Subject: VIRGIL C. SUMMER NUCLEAR STATION (VCSNS)
DOCKET NO. 50/395
OPERATING LICENSE NO. NPF-12
RESPONSE TO REQUEST FOR ADDITIONAL INFORMATION
LICENSE AMENDMENT REQUEST LAR-02-2767
STEAM GENERATOR INSPECTION FREQUENCY

**South Carolina Electric & Gas Company (SCE&G)
Virgil C. Summer Nuclear Station (VCSNS)
Response to NRC Request for Additional Information (RAI)
Regarding License Amendment Request LAR-02-2767
Steam Generator Inspection Frequency**

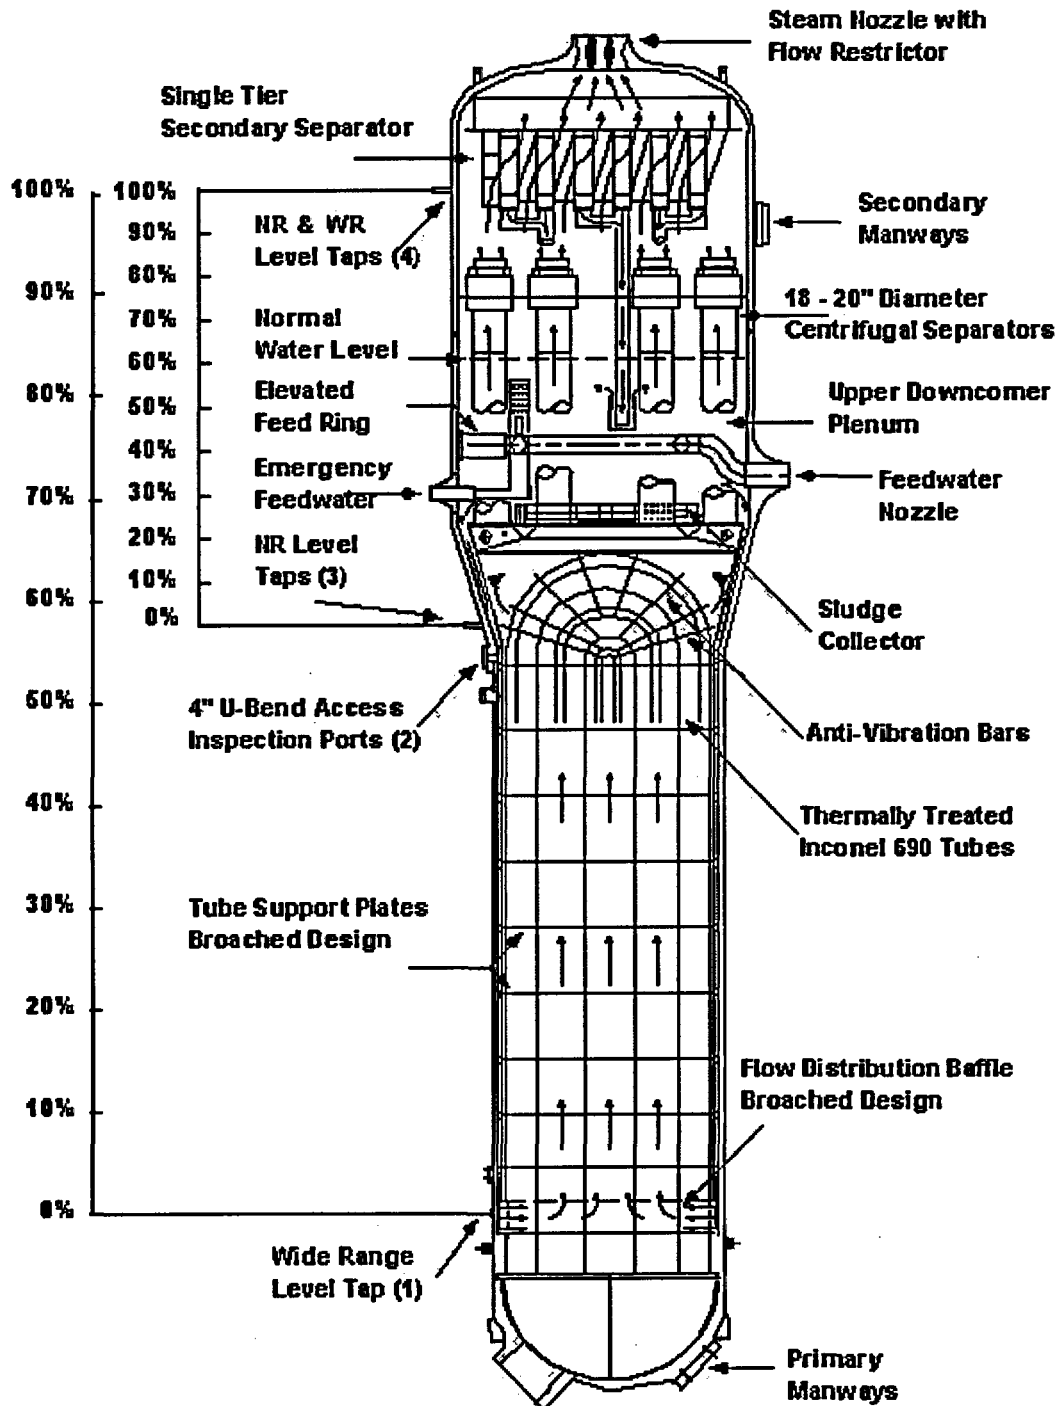
- 2. In your submittal documenting past inspection results you reference various support structures (e.g. AV7) and various tube locations (e.g. R25C26). In order to ascertain the locations of these indications, please provide a schematic of the Model Delta 75 steam generator identifying the nomenclature of the tube supports. In addition, provide a tubesheet map identifying the rows and columns of the tubes.**

A schematic of the Steam Generator (SG) structure and a tube sheet map showing row and column designations is attached.
